Access Compliance Report

Public Rights-of-Way

(Curb Ramps)

Intersection ID: 3194	Main Street: HIGHCROFT_LN	Cross Street: OLD_BRIDGE_LN	Location: SW
ADA ID: DA9A11B0276E	Ramp Type: Perp	Initial Pass/Fail: Fail	Overall Compliance: No
Severity Score: 12.5			
Codes/Mitigation Info/Possible Solution		Field Measurements/Component Compliance

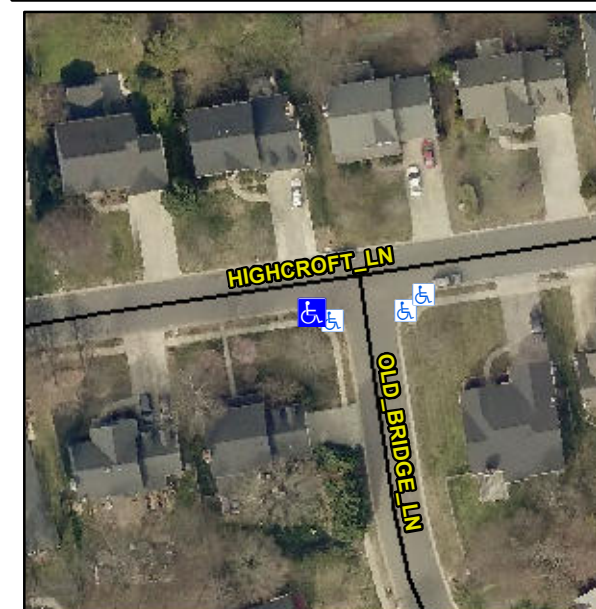
Not Found, R304.5.3

Compliance	Description	Data	Compliance	Description	Data
N/A	Ramp Length (in)	48.0	Yes	Ramp Slope (%)	5.5
Yes	Ramp Width (in)	48.0	No	Ramp XSlope (%)	6.1
N/A	Flare Type LT	N/A	N/A	Flare Type RT	N/A
N/A	Flare Slope LT (%)	N/A	N/A	Flare Slope RT (%)	N/A
N/A	Flare Traversable LT?	N/A	N/A	Flare Traversable RT?	N/A
N/A	Landing Length (in)	N/A	N/A	DWS Provided?	N/A
N/A	Landing Width (in)	N/A	N/A	DWS Contrast?	N/A
N/A	Landing Slope (%)	N/A	N/A	DWS Length (in)	N/A
N/A	Landing X Slope (%)	N/A	N/A	DWS Full Width?	N/A
N/A	Landing Curb? (Y/N)	N/A	N/A	DWS Offset (in)	N/A
N/A	Shared Landing?	N/A			
N/A	Gutter Ponding?	N/A	N/A	Gutter Slope (%)	N/A
N/A	Gutter Lip Ht (in)	N/A	N/A	Gutter X Slope (%)	N/A
N/A	Painted X Walk1?	No	N/A	Painted X Walk2?	N/A
	X Walk 1 Direction	To N		X Walk 2 Direction	N/A
N/A	X Walk 1 Width (in)	N/A	N/A	X Walk 2 Width (in)	N/A
	X Walk 1 Slope (%)	6.6		X Walk 2 Slope (%)	N/A
	X Walk 1 X Slope (%)	2.3		X Walk 2 X Slope (%)	N/A

Remove & Replace Entire Ramp.
